DUBLIN CYCLING CAMPAIGN

FINGAL CYCLING

Public Consultation on the Part VIII – Harry Reynolds Road Pedestrian and Cycle Route August 2020

Image 3: Chapel street and Harry Reynolds junction. Taken from Layout drawing 6.

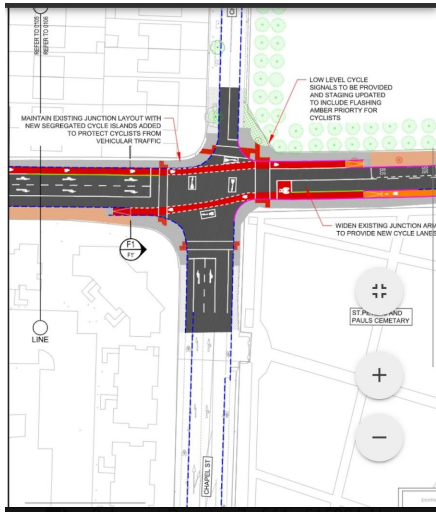
At the Chapel St. junction, the northbound cycle lane across the junction on Harry Reynolds Road sends cyclists onto the footpath instead of the road? Positive features are "segregated islands" and the proposed flashing amber lights for cyclists. But we would wish to see detailed plans for the flashing amber proposals.

The design of the junction mentions new cycle islands to protect cyclists from vehicle traffic. It's not clear from the image where these Islands will be installed. From layout drawing 6 it looks like it will be just painted lines across the junction. Are they painted islands or Kerbs? It is not clear from the drawing. The junction is not segregated and will not be safe for all ages and abilities. This does nothing to improve cycling safety especially at a busy junction like this. There is ample space to provide fully segregated
